Proposal for Supplement 1 to the 01 series of amendments to Regulation No. 129 (Enhanced Child Restraint Systems)

Supplement 1 to the 01 series of amendments to Regulation No. 129 (Enhanced Child Restraint Systems (ECRS))

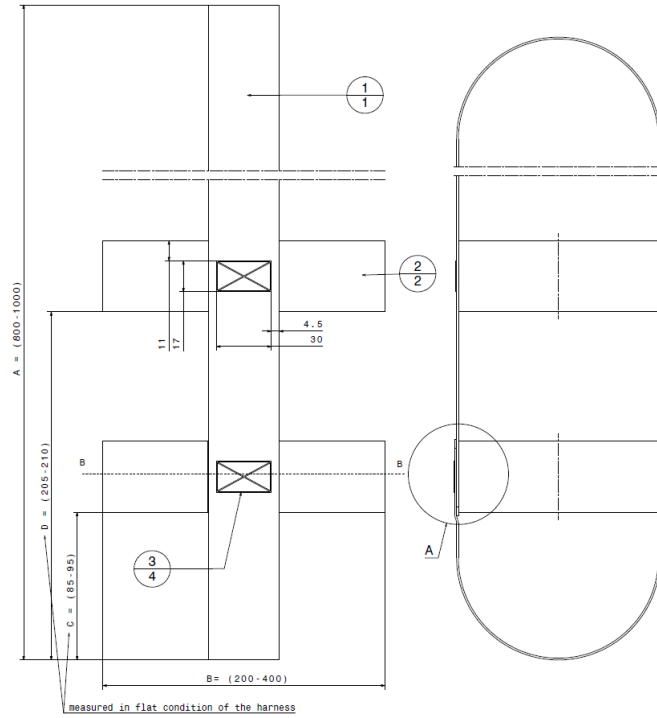
Annex 21, amend to read:

"Annex 21

...

Load application device II

... "

Figure 1

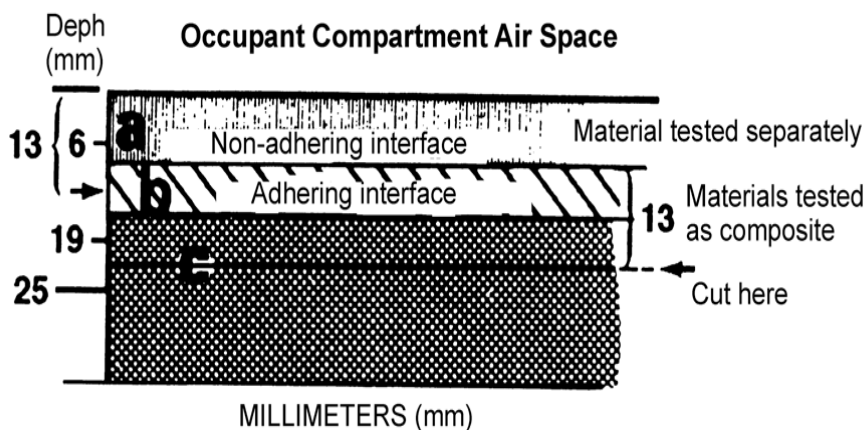
"Occupant compartment air space" means the space within the occupant compartment that normally contains refreshable air.
2. Material selection (see Figure 1 below)
 - 2.1. Any portion of a single or composite material which is within 13 mm of the occupant compartment air space shall meet the requirements in Paragraph 6.1.6.
 - 2.1.1. Any material that does not adhere to other material(s) at every point of contact shall meet the requirements of paragraph 6.1.6. when tested separately
 - 2.1.2. Any material that adheres to other materials at every point of contact shall meet the requirements of paragraph 6.1.6. when tested as a composite with the other material(s).

Material A has a non-adhering interface with material B and is tested separately.

Part of material B is within 13 mm of the occupant compartment air space, and materials B and C adhere at every point of contact; therefore, B and C are tested as a composite.

The cut is in material C as shown in Figure 1, to make a specimen 13 mm thick.

Figure 2
All dimensions in millimeters (mm)

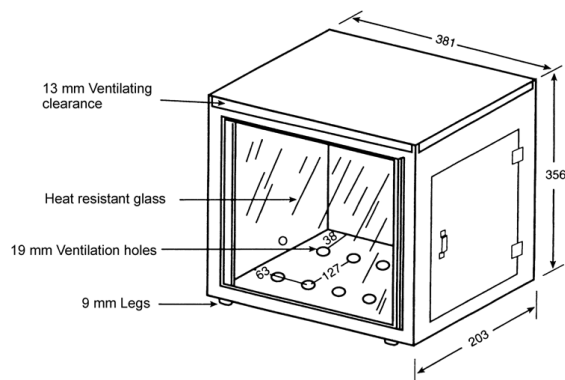
5. Test
- 5.1. Mount the specimen so that both sides and one end are held by the U-shaped frame, and specimen is not more than 51 mm, so that the sides of the specimen cannot be held in the U-shaped frame, place the specimen in position on wire supports as described in 2.3, with one end held by the closed end of the U-shaped frame.

- 5.2. Place the mounted specimen in a horizontal position, in the center of the cabinet.
- 5.3. With the flame adjusted according to 2.4, position the bunsen burner and specimen so that the center of the burner tip is 19 mm below the center of the bottom edge of the open end of the specimen.

- 5.4. Expose the specimen to the flame for 15 seconds.
- 5.5. Begin timing (without reference to the period of application of the burner flame) when the flame from the burning specimen reaches a point 38 mm from the open end of the specimen.

- 5.6. Measure the time that it takes the flame to progress to a point 38 mm from the clamped end of the specimen. If the flame does not reach the specified end point, time its progress to the point where flaming stops.
